June 4, 2003
LIC-03-0081

SUBJECT: Response to Request for Additional Information, Pressure-Temperature Limits Report Amendment Request; Low Temperature Over Pressure

Response to NRC Request for Additional Information Pressure-Temperature Limits
Report (PTLR); Low Pressure Over Temperature

Comparison between RELAP5/MOD 3.2 and RELAP5/MOD 3.3

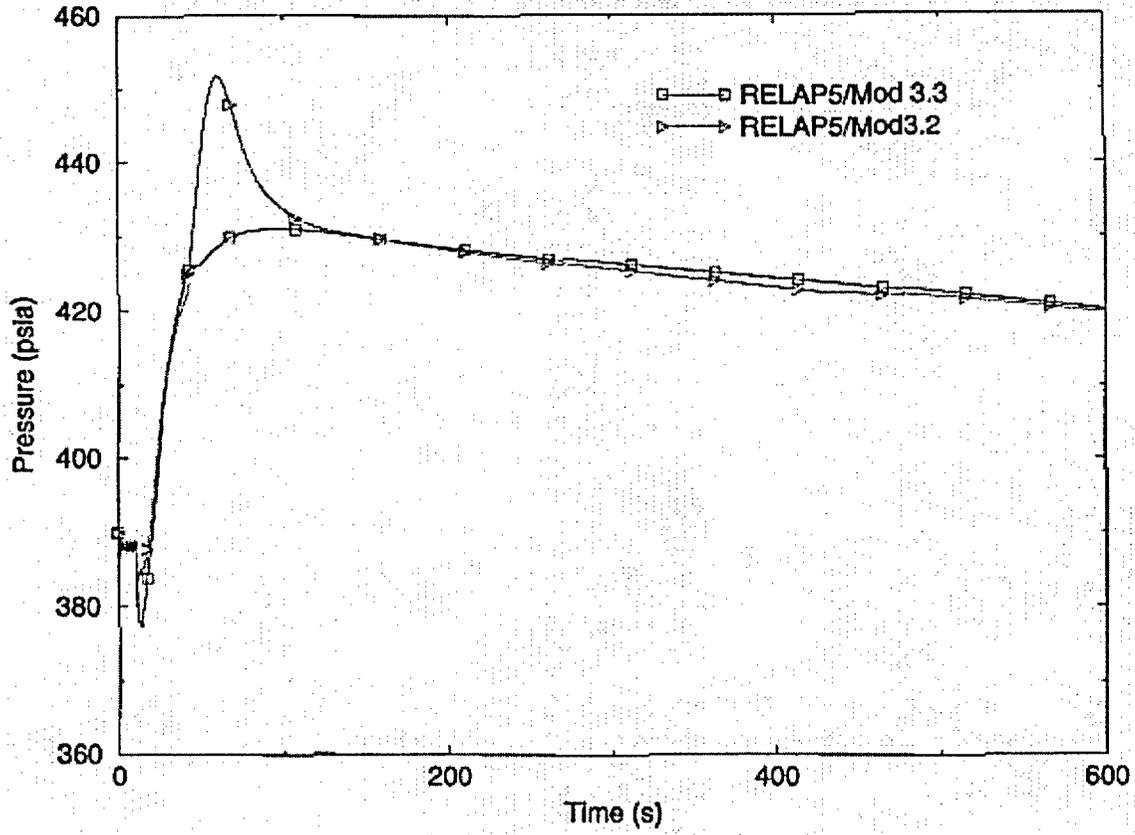
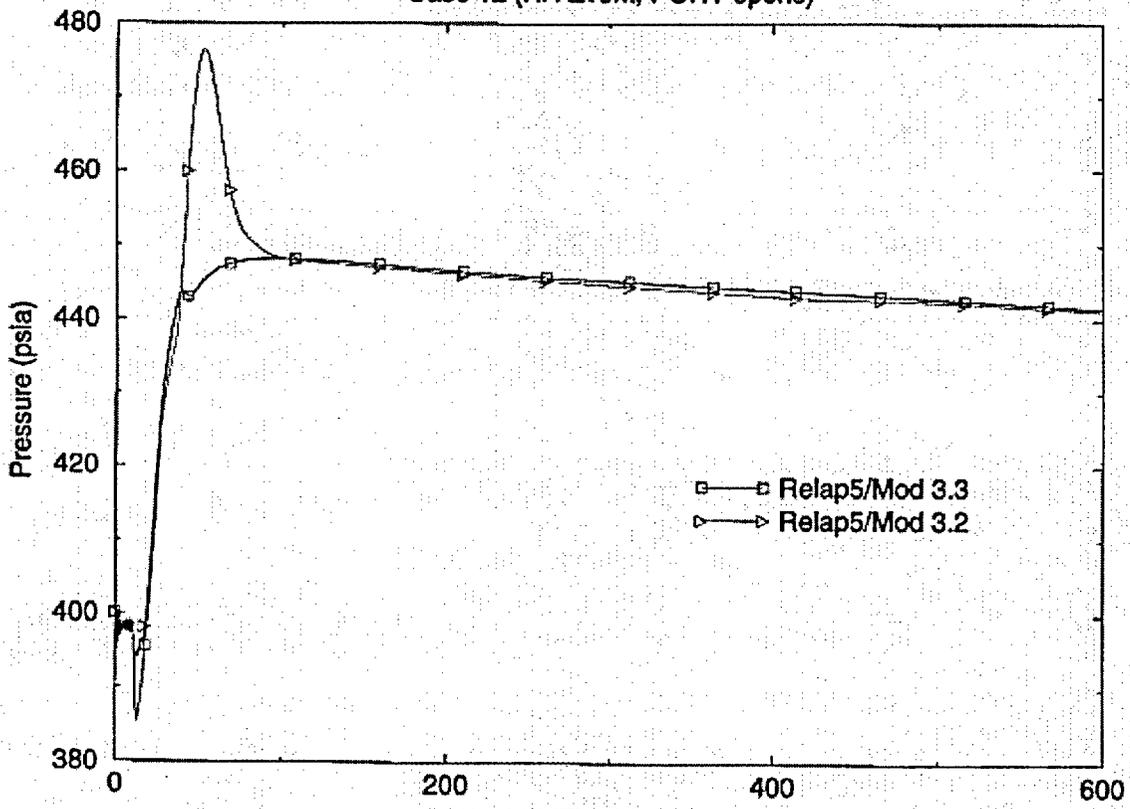
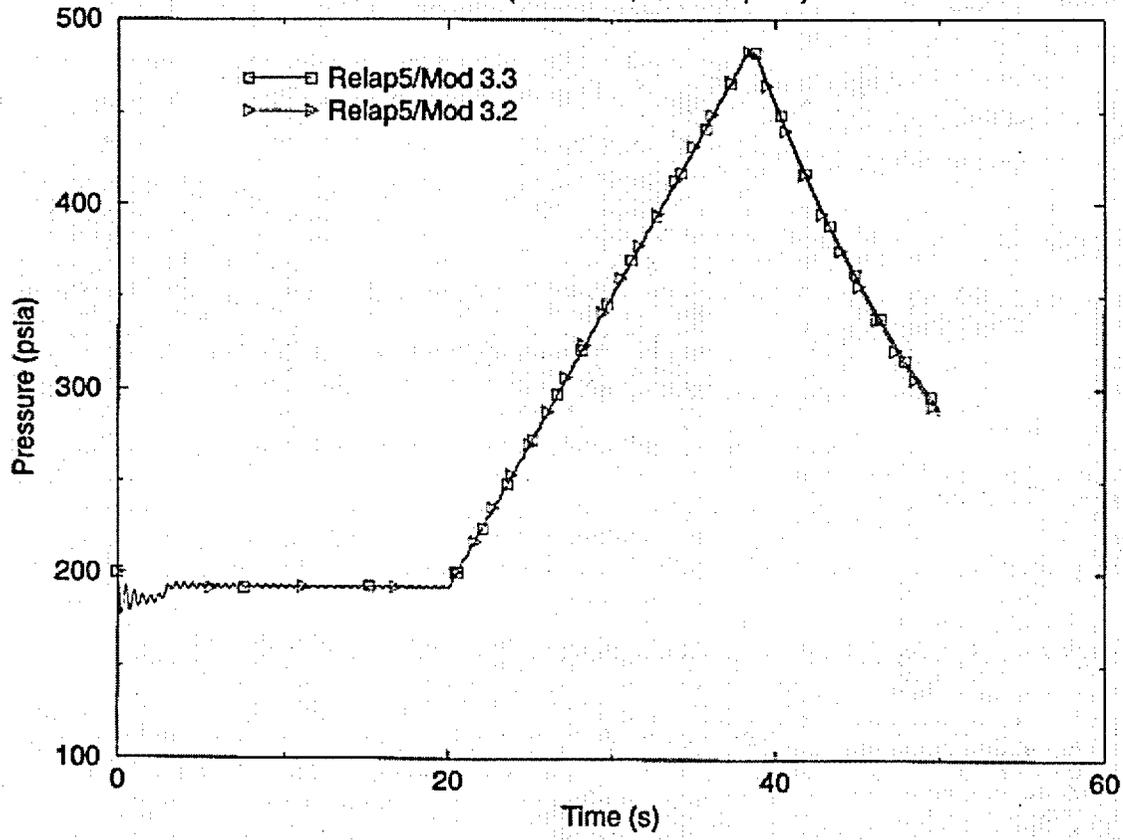
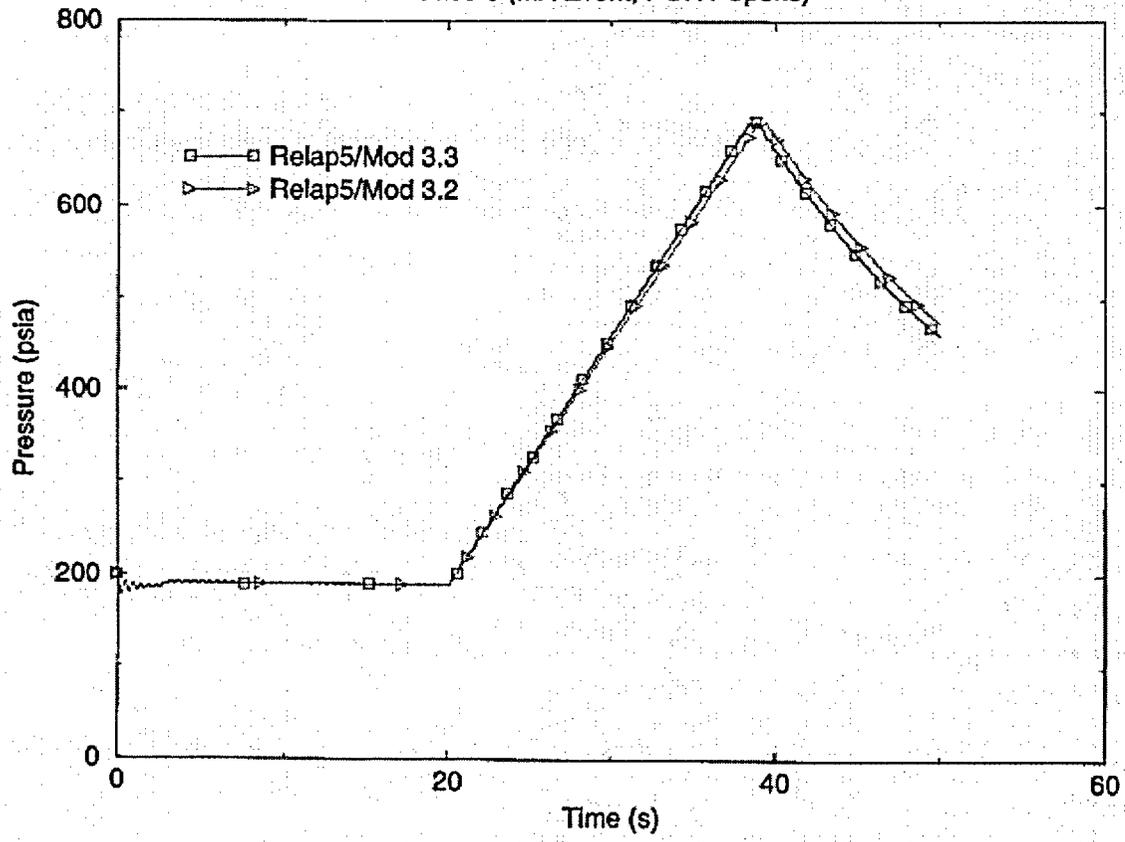
The LTOP analysis employed RELAP5/MOD3.2 which is not the latest version. RELAP5/MOD3.3 contains improved water property data at low pressure. Why was not RELAP5/MOD3.3 used and what would have been the impact on the LTOP transients?

RELAP5/MOD 3.3 was not used to perform the low temperature overpressure protection (LTOP) analysis due to the analysis being completed prior to the release of the RELAP5/MOD 3.3 code. The impact it would have had on the analysis is described in Appendix 1.

An evaluation was performed to compare the results of RELAP5/MOD 3.2 and RELAP5/MOD 3.3 for a few select low temperature overpressure protection case runs (Reference D). For each overpressure event (i.e. heat and mass addition) two case runs were performed using RELAP5/MOD 3.3. No modeling changes were performed for any of the cases.

For the heat addition event (HA), Cases 11 and 12 were performed. Please refer to Figures 1 and 2. These figures demonstrate that using RELAP5/MOD 3.3, the resultant peak pressure is significantly lower and depicts the two codes having essentially the same trend. The conclusion is that both codes seem capable in determining the peak pressure following a HA event and demonstrate essentially the same trends. For both HA cases, it appears that RELAP5/MOD 3.2 conservatively predicts a higher peak pressure.

For the mass addition (MA) event, Cases 2 and 6 were performed. Please refer to Figures 3 and 4. These figures demonstrate that using RELAP5/MOD 3.3, the resultant peak pressure is essentially identical to that predicted by RELAP5/MOD3.2 and depicts the two codes predicting essentially the exact same trend. The conclusion is that both codes are capable of determining the peak pressure following a MA event and demonstrate essentially the same peak pressure and trend.

The overall conclusion of the comparison between RELAP5/MOD 3.3 and RELAP5/MOD 3.2 is that it appears the improved water property tables provide an improvement (i.e. a lower peak pressure) in determining the peak pressure following a HA event. In the four test cases that were performed, the peak pressure is higher using RELAP5/MOD 3.2 (HA events only) and both codes predict essentially the same trends. Thus it is concluded that RLAP5/MOD 3.2 provides conservative results and thus its application for the Fort Calhoun Station LTOP analysis is also valid and conservative.

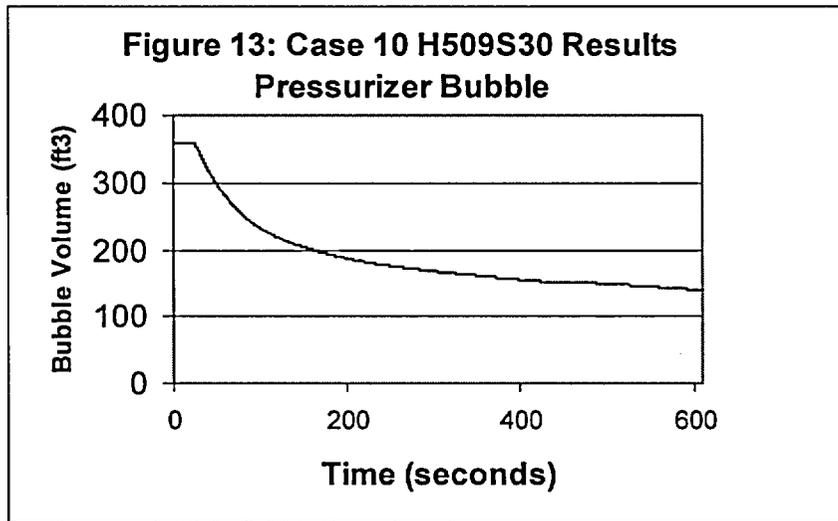
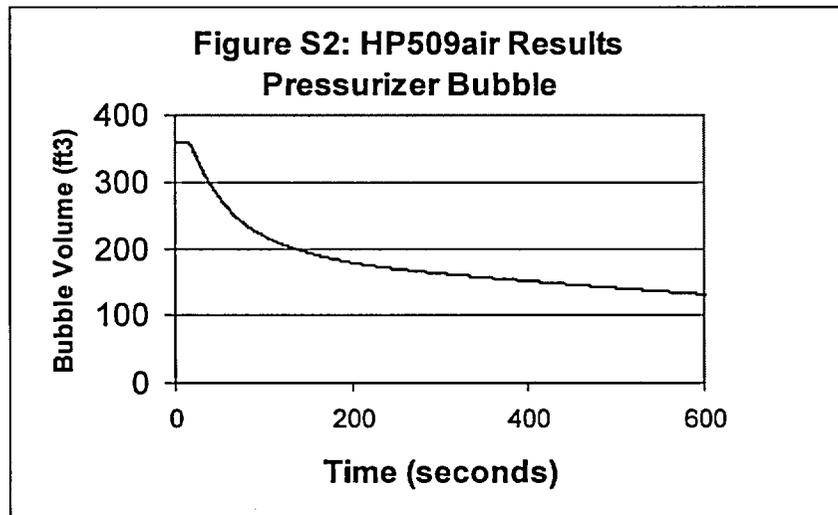
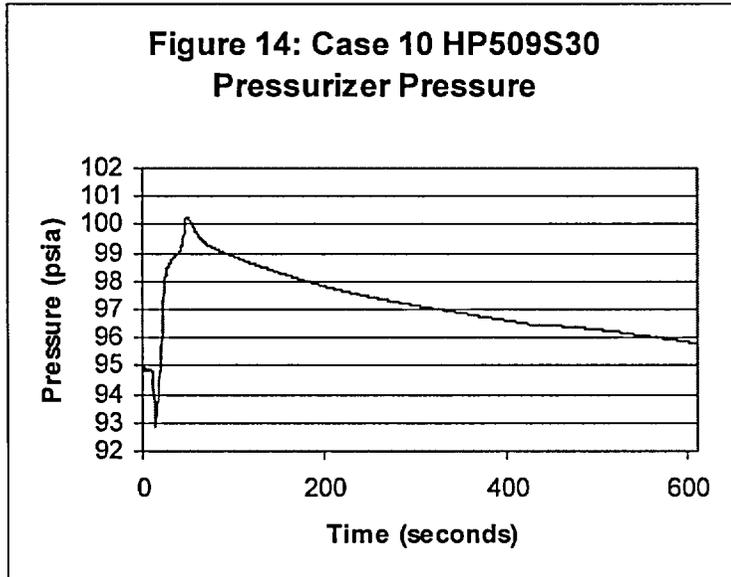
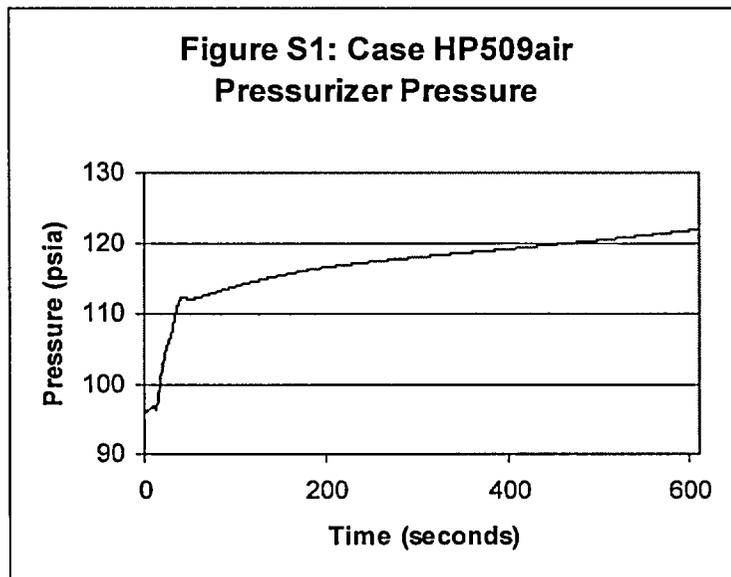
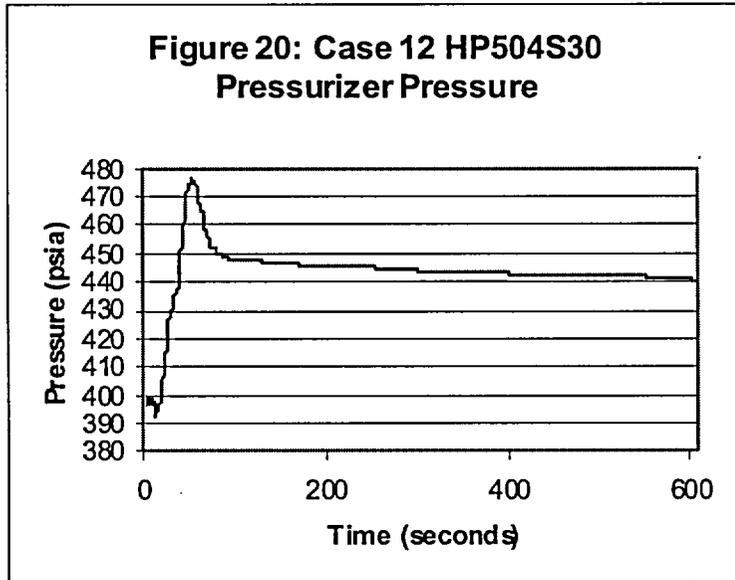
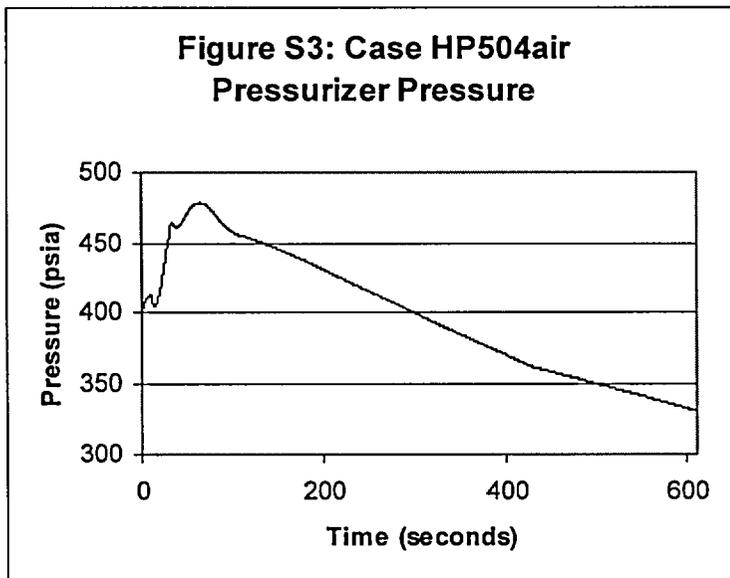
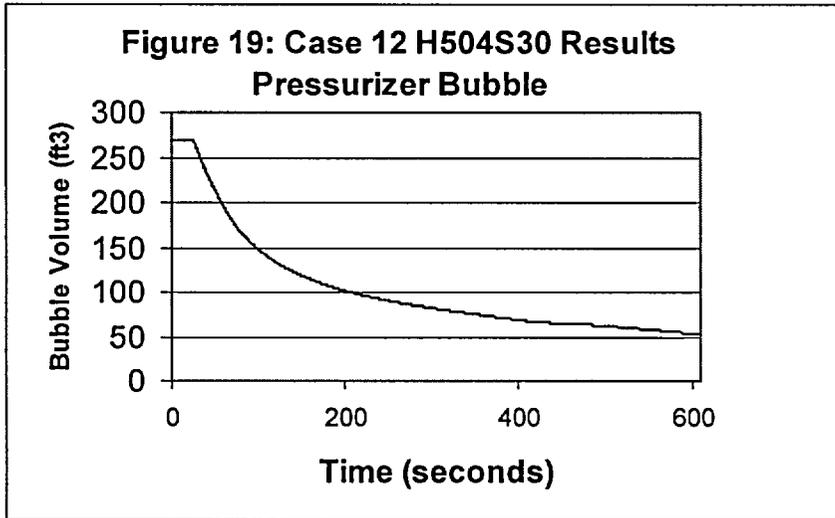
Non-condensables collect in the pressurizer and the upper vessel head. Please describe the impact of non-condensables on the LTOP analysis. Are there any scenarios where non-condensables can affect the calculated peak pressure and the development of the LTOP limits?

As noted in Response to NRC Question 7, any increase in the elasticity of the RCS slows the pressurization rate, so the presence of non-condensables in the water solid transients is a benefit because it decrease the pressure rise between the time that the setpoint is reached and the PORV opens. Since the need is to remove volume from the RCS, and gas flow through a PORV has a much higher volumetric flow rate than water flow, any non-condensables present at the time of PORV opening would also be a benefit for the water solid transients. For steam bubble cases, the effect of non-condensables could be to increase pressure, since the non-condensable gas could not condense to a liquid phase. A confirming evaluation was performed and is attached as Appendix 6. However, the final conclusion is that the slightly higher peak pressures are still well below the PORV setpoints. An additional case in Appendix 6 verifies that if the PORV setpoint was reached due to unusual initial conditions, the non-condensable gas provide adequate volumetric relief. This additional case verified the final conclusion of Case 12 in Reference D, i.e., the PORV lifting on a steam bubble cases provides fast pressure relief and a less limiting peak pressure than the water-solid transients.

A confirming evaluation was performed which concludes that assuming non-condensable gases present within the steam in a pressurizer bubble has no significant impact. The worst case in terms of shrinking the bubble, Case 10 HP509S30 of Reference D, was rerun with an assumed 10% non-condensable gas. The bubble was slightly smaller and the pressure slightly higher, but the change does not impact the analysis conclusions. Case 12 of Reference D, where the input is adjusted to result in a PORV opening, was also re-performed with 10% non-condensables.

For Case 10, there is still a significant bubble left at 600 seconds, but it is slightly reduced from 139.0 ft³ to 130.1 ft³. Without non-condensables, the pressure only went up to 100.3 psia and then came back down. For this analysis it rose to 112 psia, and then returned slowly to 122 psia at 600 seconds. Please refer to the figures below for comparison.

The conclusion is that the non-condensable gases have no significant impact. The bubble is very slightly smaller, but there is still adequate bubble remaining after 10 minutes. The pressure is slightly higher, but that is unimportant since the PORV setpoint is still far away from being reached. Case 12 was run to show that even if the PORV does lift (due to an assumed high initial pressure) the transient is successfully mitigated. Re-performing Case 12 showed a tiny increase in the peak pressure (from 476 to 478 psia), but more rapid depressurization after the valve opens and a growing bubble at 600 seconds.
